City of Rockport

CITY COUNCIL REGULAR MEETING AGENDA

18. Consider the approval of Construction Change Directive #4 related to the new City Hall project

Consider the approval of Construction Change Directive #5 with Teal Construction related to the new City Hall project (cost pending)

1004335.02

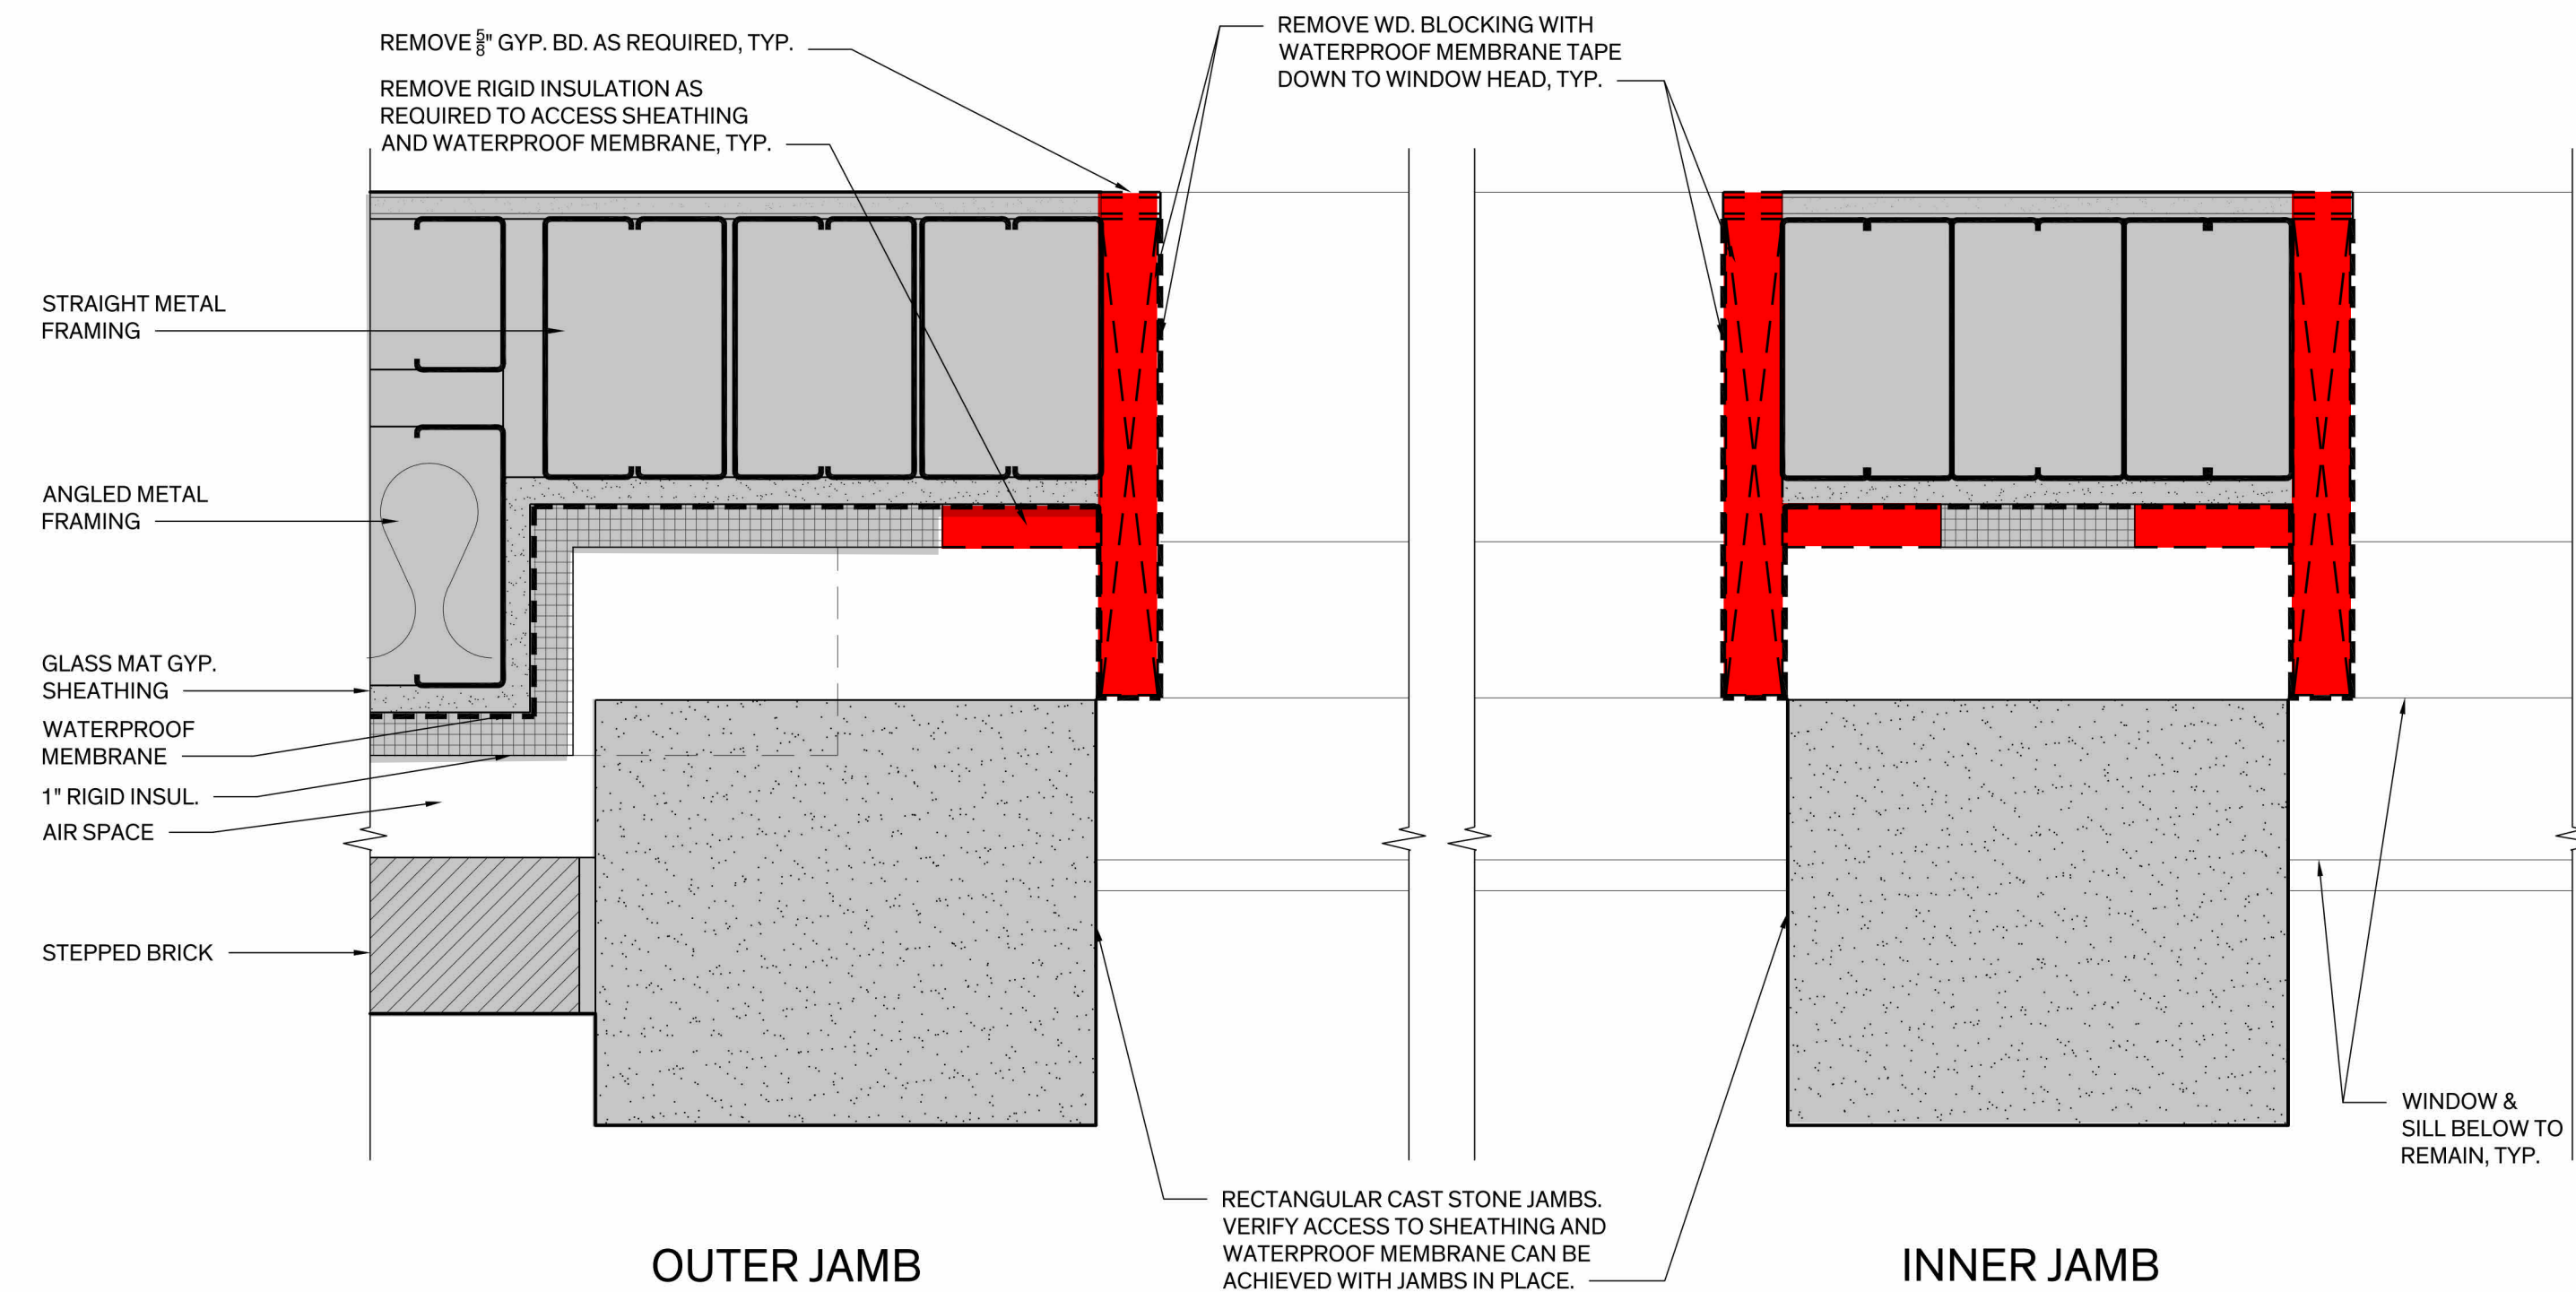
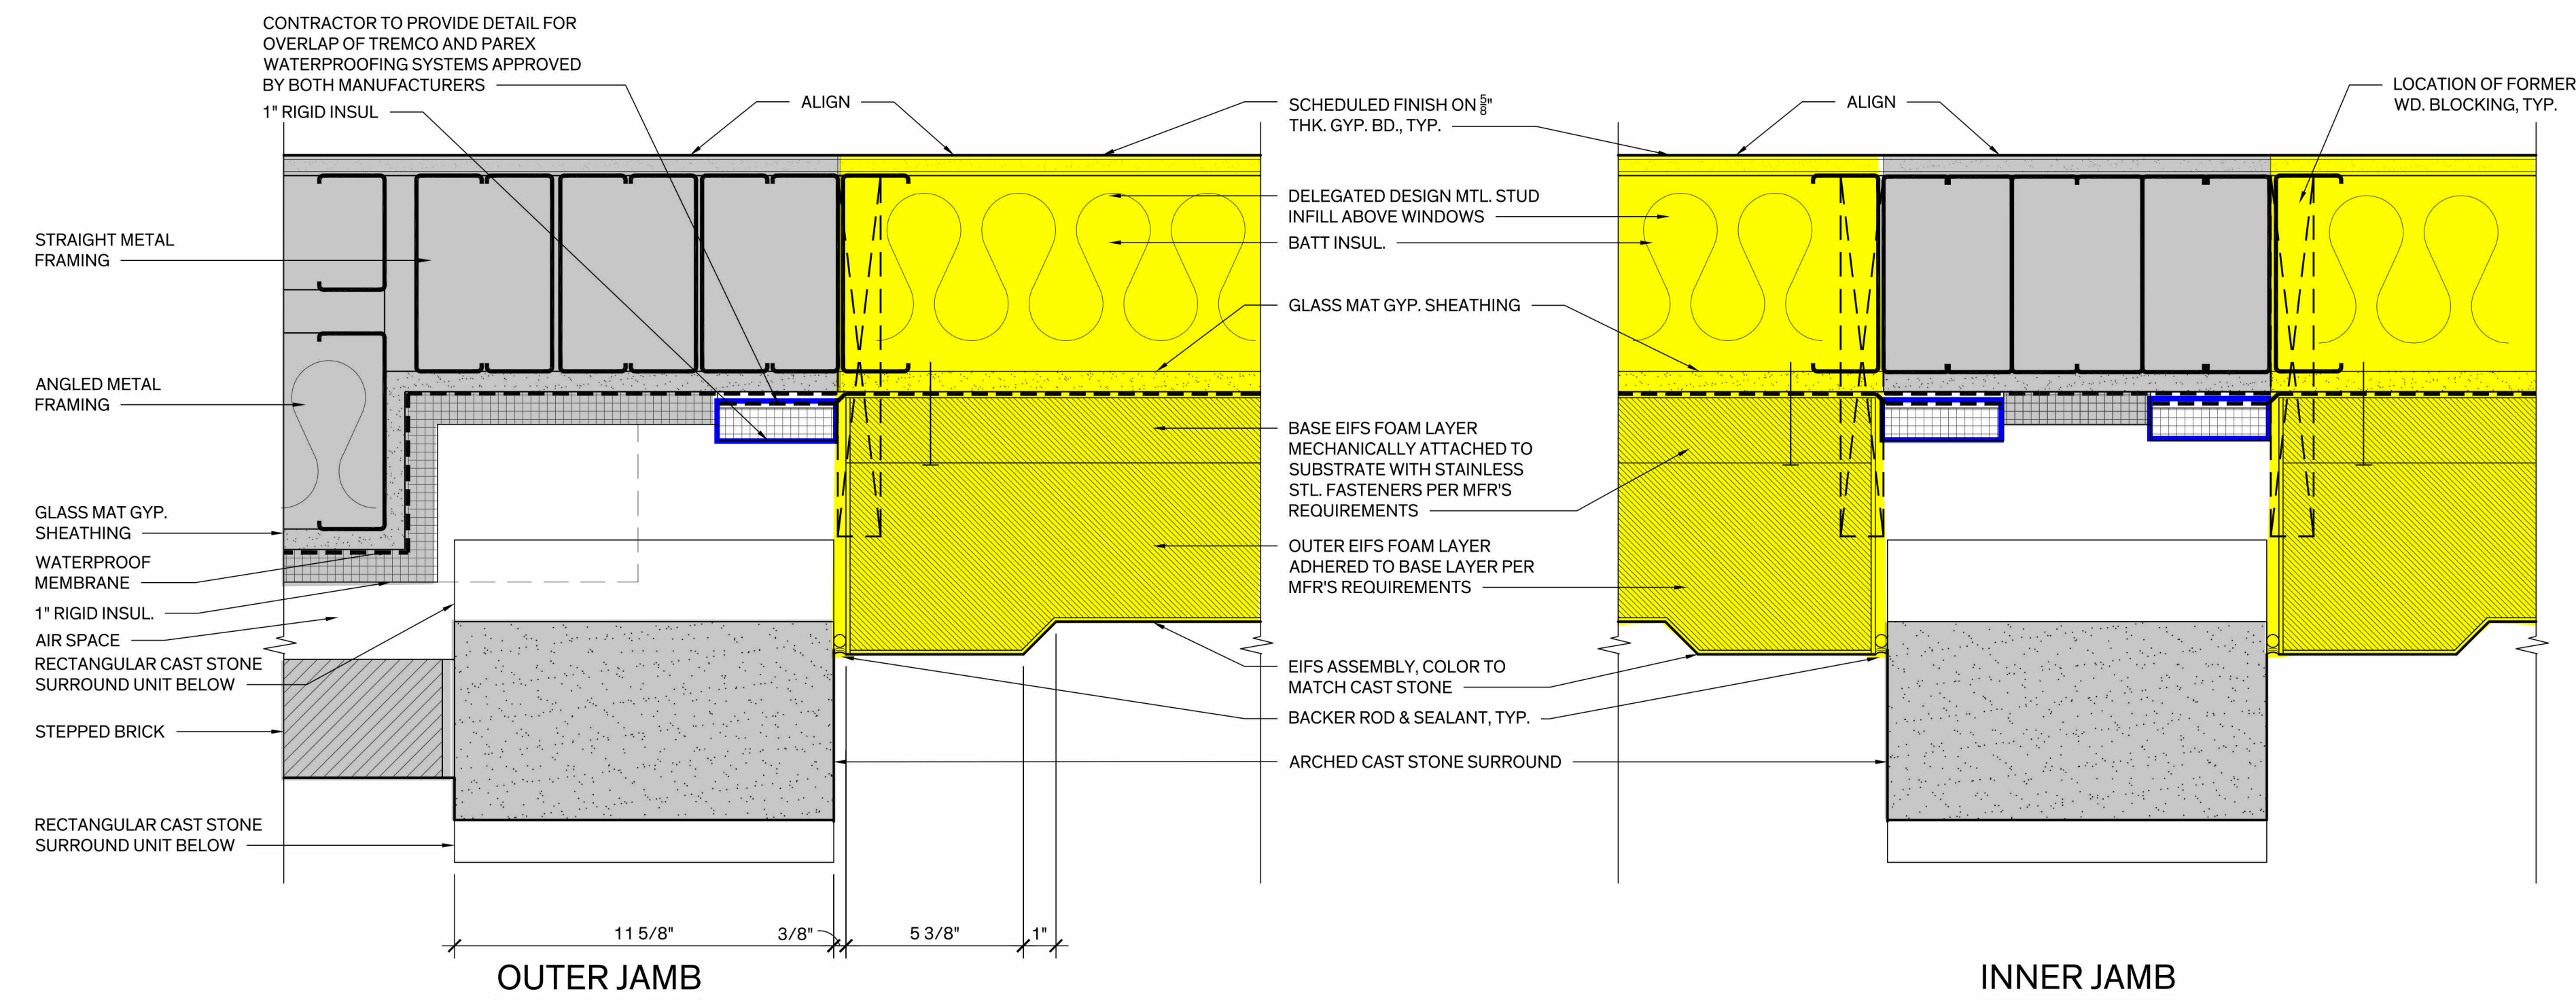
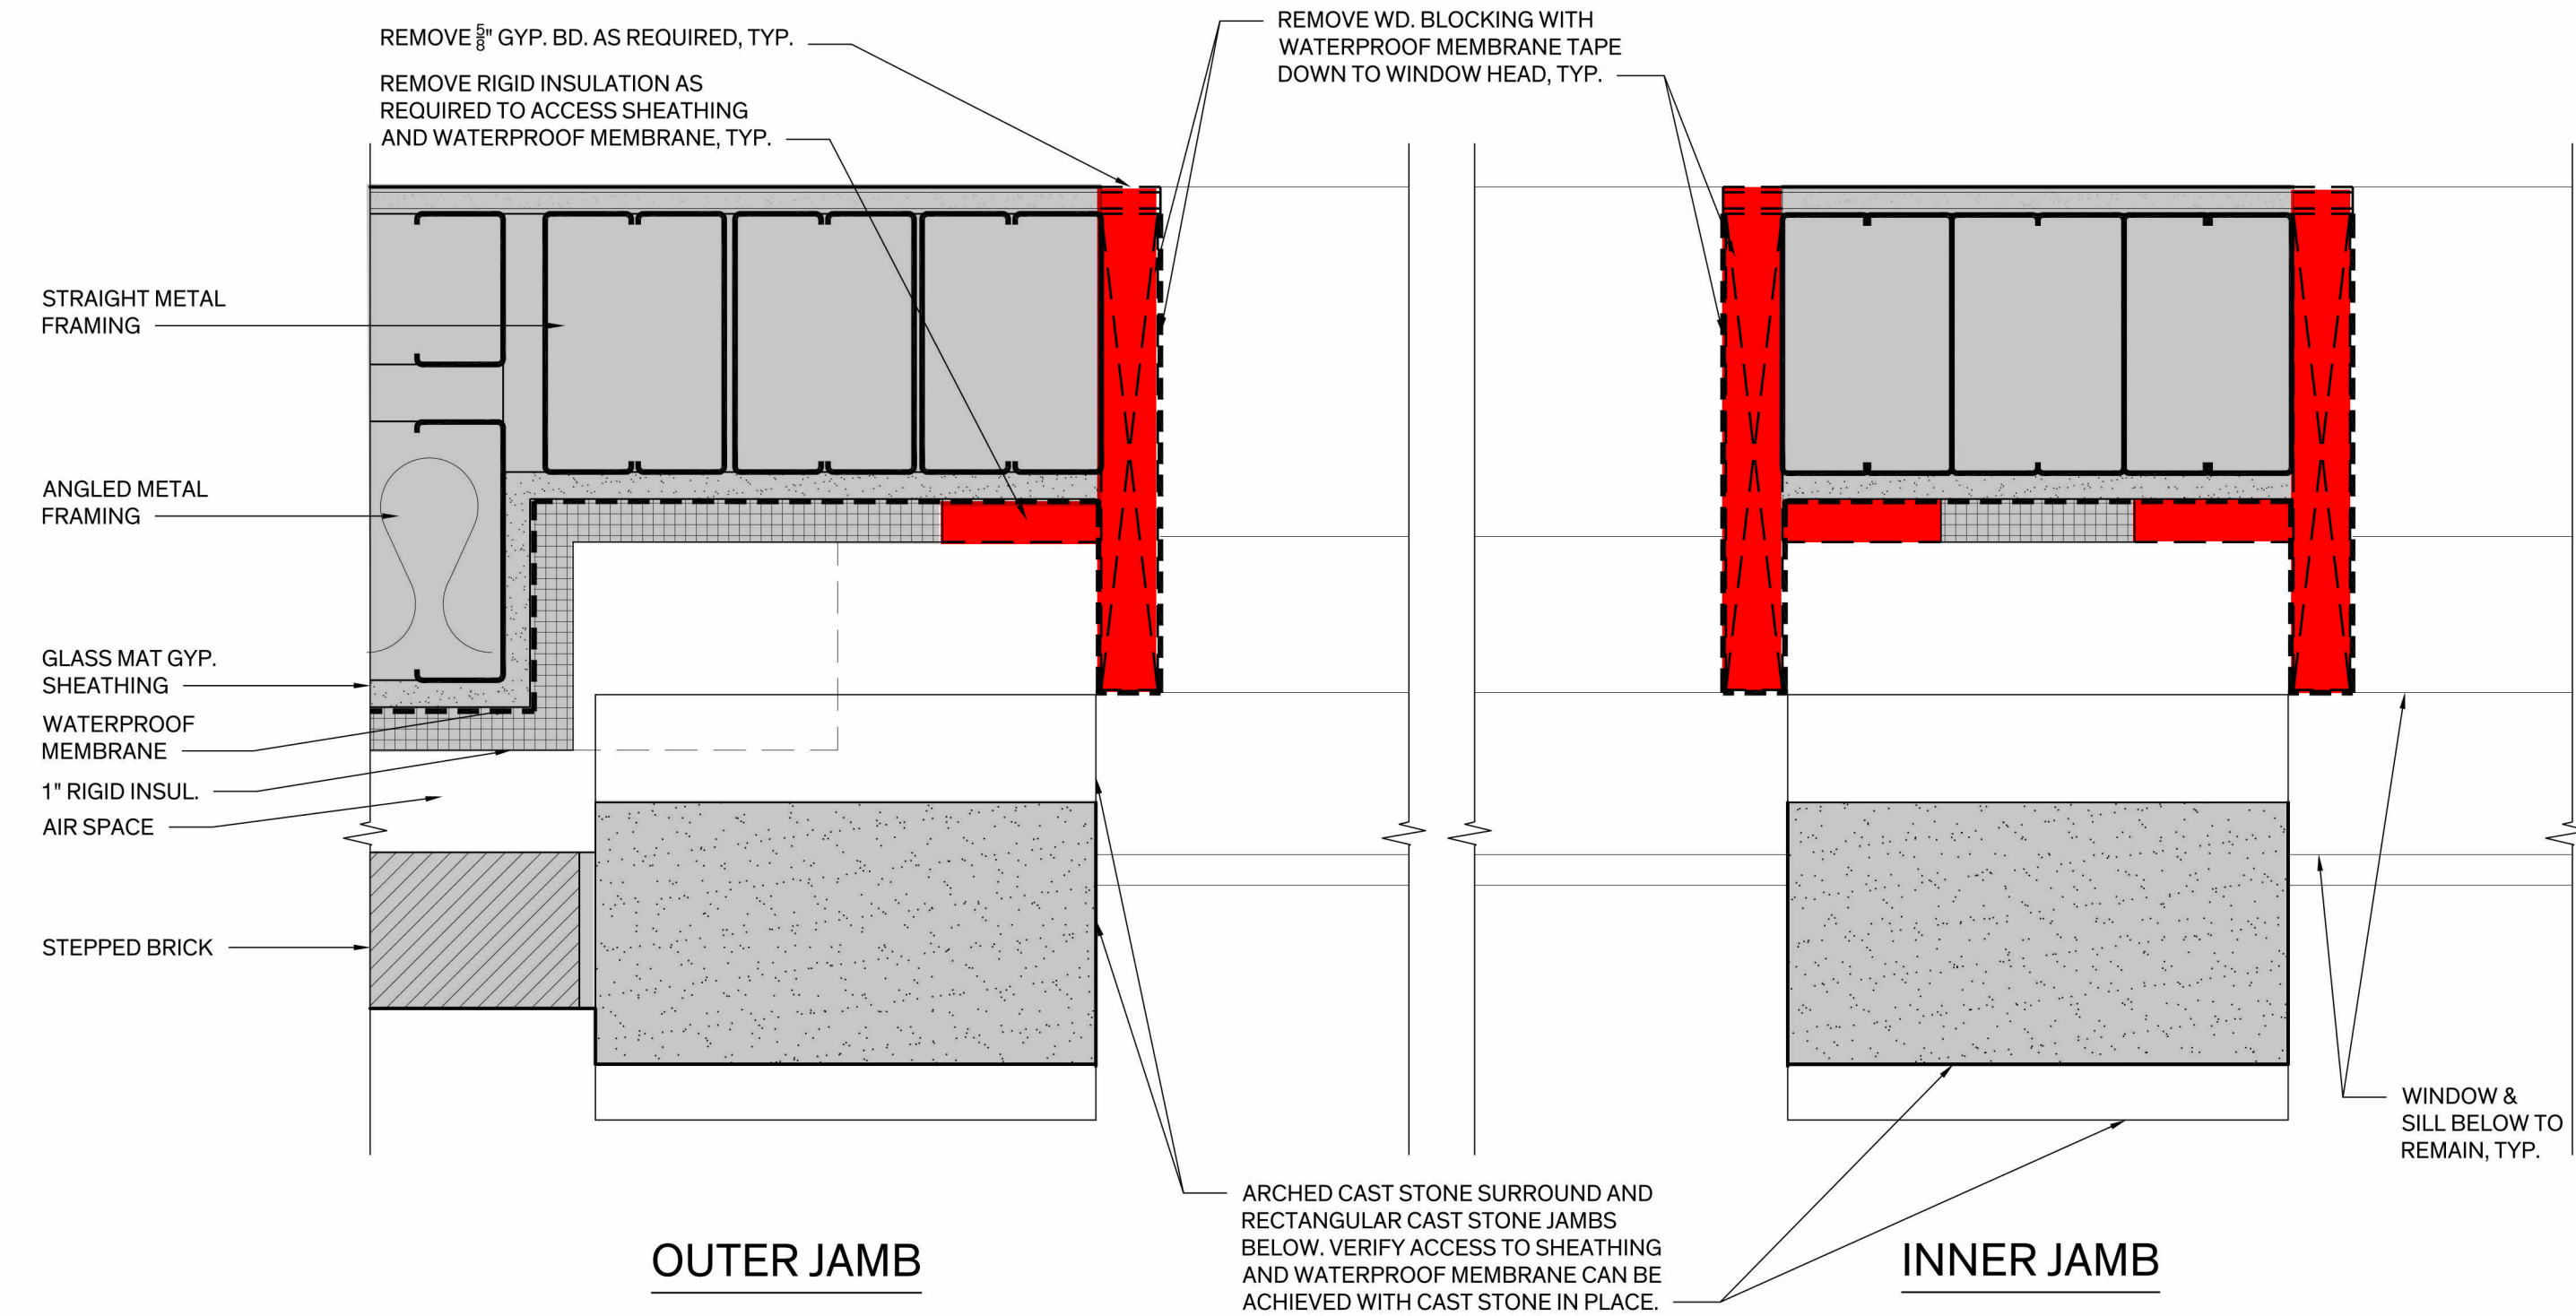
REMOVE		INFILL REQUIRED AT EIFS PANELS
	AS-BUILT TO REMAIN		REINSTALL REMOVED COMPONENTS

Provide EIFS infill with recessed panel detailing within arched openings above tower windows. Refer to attached revised SK-3A, SK-3B, SK-3C, SK-3D, and new SK-3E.

DRAWING NO.
SK3
SCALE: AS NOTED
SHEET NAME
SECTIONS

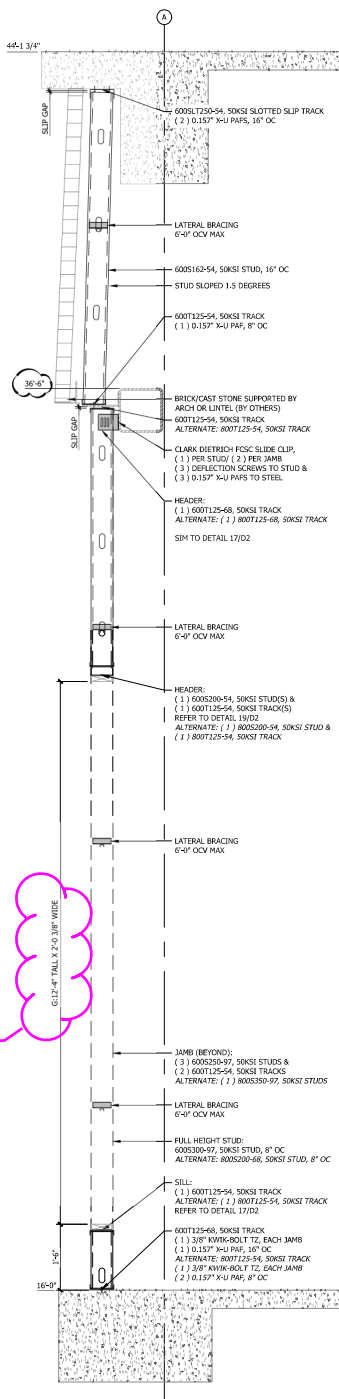
Description: This proposal is for the additional engineering to infill the sprandel on top of the windows at the tower walls and add support. Please note that we are no longer in the project and an this work will required an additional movilization and ordering a boom lift to access the work area. Also, we do not have material on site and they do not sell by the piece for the special order material only by bunddles.

Verify with actual window dimensions. Type G frame height is 144-13/16\"/>
